UNITED STATES PATENT AND TRADEMARK OFFICE

APPLICATION NO.	FILING DATE	FIRST NAMED INVENTOR	ATTORNEY DOCKET NO.	CONFIRMATION NO.
10/573,686	03/27/2006	Koetsu Saito	L8638.06105	7158
52989	7590	02/27/2009	EXAMINER	
Dickinson Wright PLLC			GORDON, BRYAN P	
James E. Ledbetter, Esq.				
International Square			ART UNIT	PAPER NUMBER
1875 Eye Street, N.W., Suite 1200				2834
Washington, DC 20006				
			MAIL DATE	DELIVERY MODE
			02/27/2009	PAPER

Office Action Summary	Application No.	Applicant(s)	
	10/573,686	SAITO ET AL.	
	Examiner	Art Unit	
	BRYAN P. GORDON	2834

DETAILED ACTION

Figure 3

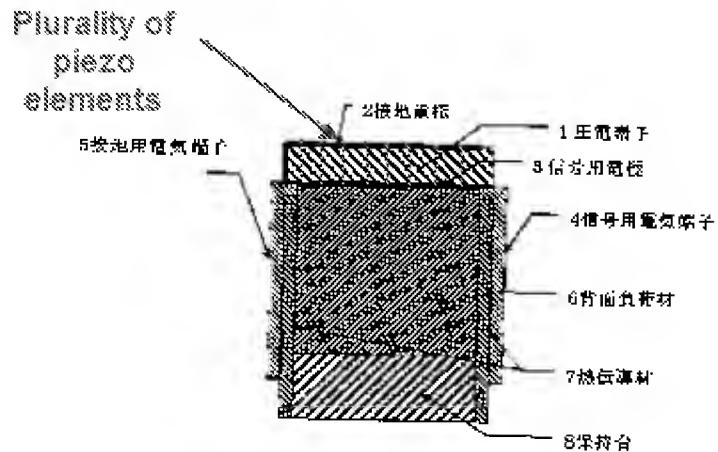
5. Claims 1-2, 5 and 9 are rejected under 35 U.S.C. 103(a) as being unpatentable over Takayoshi (JP 2000165995) in view of Greenstein (US PN 5,592,730).
6. Considering claims 1-2, Takayoshi (Figure 3) teaches a piezoelectric element (1) for transmitting and receiving ultrasonic waves (paragraph 0003); a backing load member (6) placed on a rear surface of said piezoelectric element.

However, Takayoshi does not teach a heat conduction material which is placed inside said backing load member and whose thermal conductivity is greater than a thermal conductivity of said backing load member.

In the same field of endeavor, Greenstein (Figure 14) teaches a heat conduction material (22) (electrical traces also provide a path for heat to flow) which is placed inside said backing load member (16) and whose thermal conductivity is greater than a

thermal conductivity of said backing load member for the benefit of transferring the heat produce from the electricity flow.

Therefore, it would have been obvious to one of ordinary skill in the art at the time the invention was made to include a heat conduction material which is placed inside said backing load member and whose thermal conductivity is greater than a thermal conductivity of said backing load member with Takayoshi's device for the benefit described above.
